Sub Regional RTEP Committee PJM West

March 19, 2020

Project Update

AEP Transmission Zone: Baseline B3131 Scope Change

DLC Duquesne Transmission Zone Baseline Crescent 138 kV Breaker "2-5 TIE"

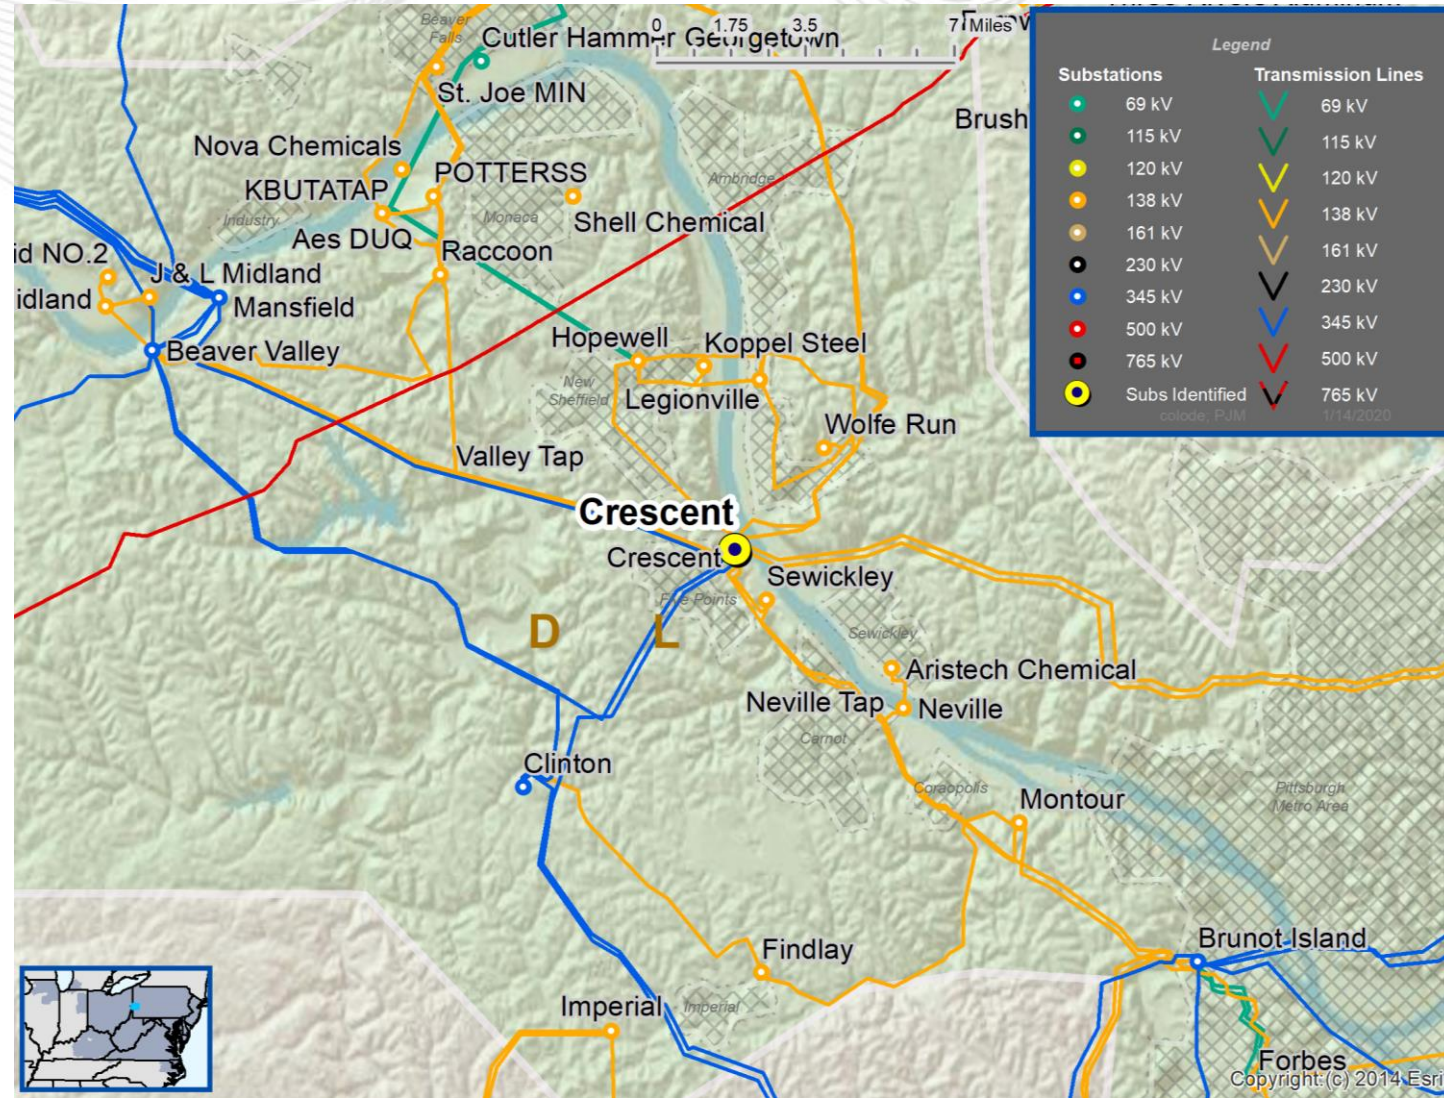
The Crescent 138 kV oil-type breaker "2-5 TIE" is found to be over duty following a model review and correction to short circuit base case.

The "2-5 TIE" breaker shall remain opened and out of service until it can be replaced with a DLC standard 138kV 63 kA breaker (B3212)
